**FIRE SERVICES DEPARTMENT  
FIRE PROTECTION COMMAND**

本處檔號 Our Ref.: FPB 314/38 III

16 September 1994

**FSD Circular Letter No. 2/94**  
**Rules for Automatic Sprinkler Installations**

**Figure 7. Superior supply using town main**

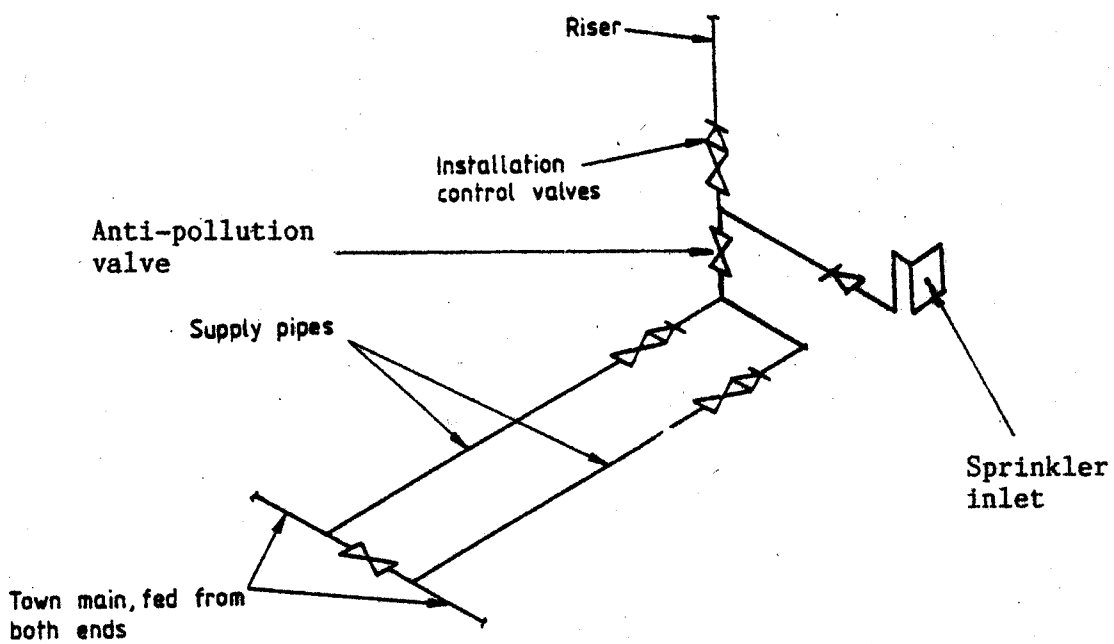
| <u>Item</u> | <u>Clause/Paragraph</u><br><u>/Table/Page</u>                                    | <u>Context</u>   | <u>Replaced by</u>   | <u>Reason</u>  |
|-------------|--|--|--|--|
| 4.3         | Figures 7, 9, 10, 12, and 14 to 18 (Pages 35, 37, 38, 41, 43, 44, 45, 46 and 47) | <p>Figure 7. Superior supply using an unrestricted town main</p> <p>Figure 9. Superior supply using gravity tank</p> <p>Figure 10 Superior supply using suction pumps</p> <p>Figure 12 Duplicate supplies using two town mains</p> <p>Figure 14 Duplicate supplies using selection from suction pump/pressure tank/gravity tank</p> <p>Figure 15 Duplicate supply using two gravity tanks</p> <p>Figure 16 Duplicate supplies using a private reservoir and a pressure tank</p> <p>Figure 17 Duplicate supplies using two suction pumps from river or canal (suction lift condition)</p> <p>Figure 18 Duplicate supplies using two suction pumps from a limited capacity tank and full capacity tank</p> | To include the local requirements into these figures and as shown in Appendix 1 to 9.                                      | To avoid confusion particularly in water connections.  |
